Allegheny National Forest  
Bradford Ranger District

Date: June 8, 2007

The Forest Service, surface landowner of the Allegheny National Forest (ANF) in northwest Pennsylvania, files this official objection to the well permit applications submitted by Duhring Resource Company in a revised proposal package on May 26, 2007. The objection is for four (4) wells located in Sheffield Township, Warren County, Pennsylvania on Warrant 2445. This objection pertains to Title 58, Section 601.205 of the Pennsylvania Oil and Gas Act, "Well Location Restrictions."

Duhring Resource Company Well sites/road Objections

Picture of wetland from bank above well 7-22, looking towards SR 948

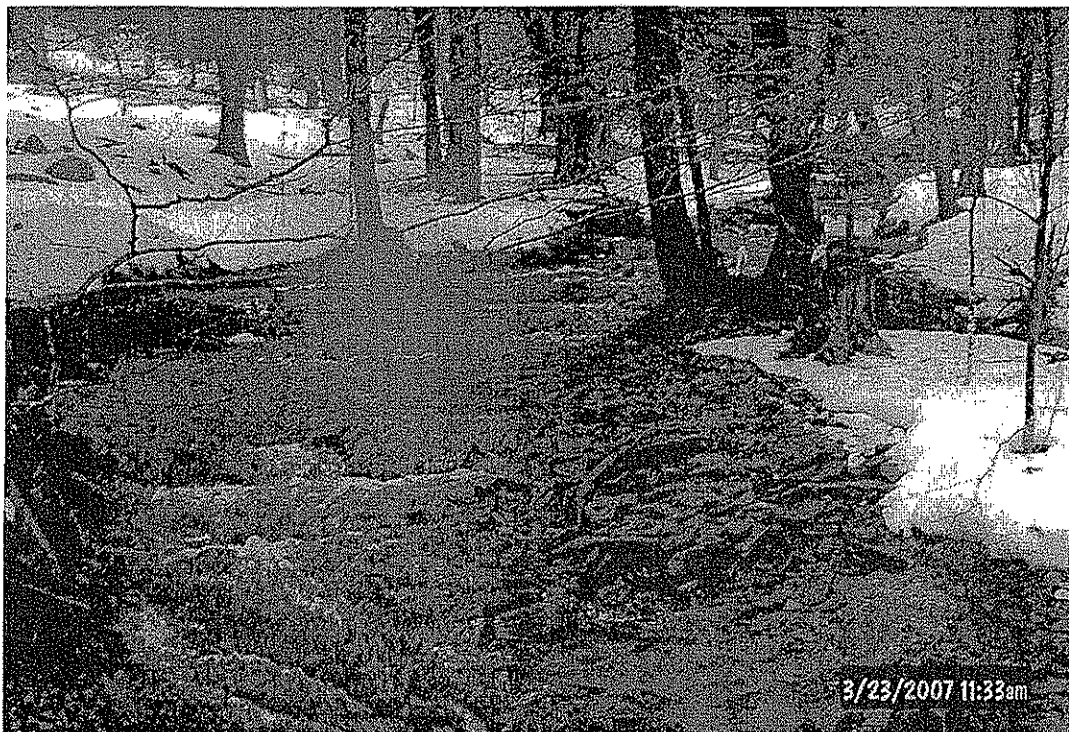
The wells in objection in Warrant 2752, Lot 7, are numbered 7-18, 7-20, 7-21, and 7-22. The Well (Farm) name is Lot 7 and is located within the Sheffield and Ludlow Quadrangles. The well plats for the objected wells were submitted to the Bradford District Office on March 20, 2007. As proposed, Well 7-18 and the access road would directly impact the North Country National Scenic Trail (NCNST) as administrated by the National Park Service. The NCNST was federally designated as a National Scenic Trail in 1980 under Public Law 90-543. Wells 7-20 and 7-21 are proposed within large spring seeps (wetlands) that drain directly into a wetland west of SR 948. Well 7-22 is proposed within this wetland. Please see the attached pictures.
